INCH-POUND
MIL-H-24136A(SH)
AMENDMENT 3
29 October 1991
SUPERSEDING
MIL-H-24136A(SH)
AMENDMENT 2
12 April 1991

MILITARY SPECIFICATION

HOSE, SYNTHETIC RUBBER, SYNTHETIC FIBER REINFORCED, AND END FITTINGS, REUSABLE, FOR FLEXIBLE HOSE ASSEMBLIES, GENERAL SPECIFICATION FOR

FIGURE 4. Pressure time curve for impulse test.

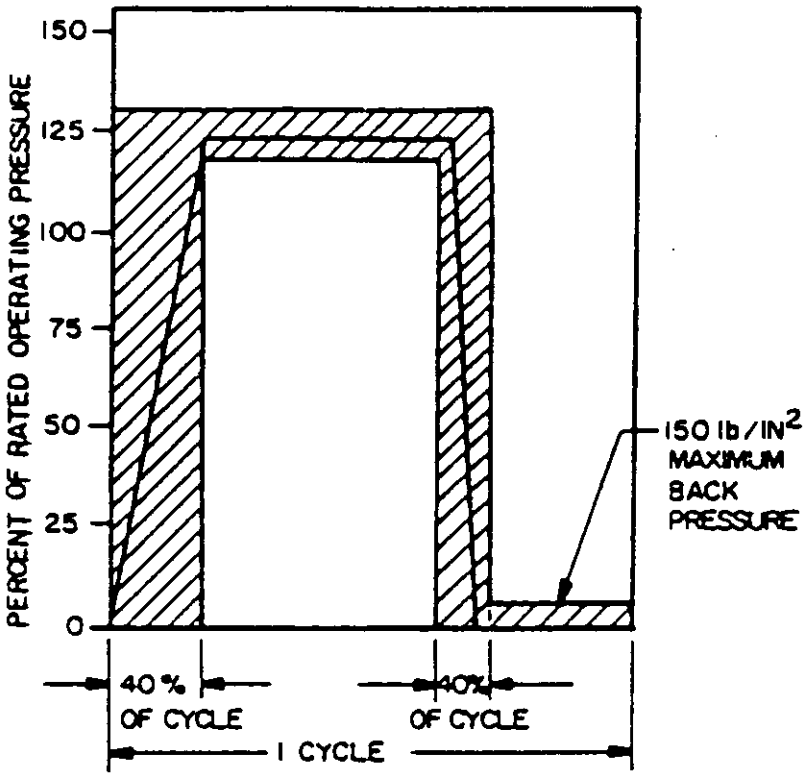
FIGURE 4: Add new figure, attached:

For hose sizes larger than 5 inches (-80)

NOTE: The curve is the approximate pressure time cycle for the pressure impulse to be used in performing the impulse test specified in 4.6.5. The actual pressure time cycle obtained when performing this test should fall within the shaded area.
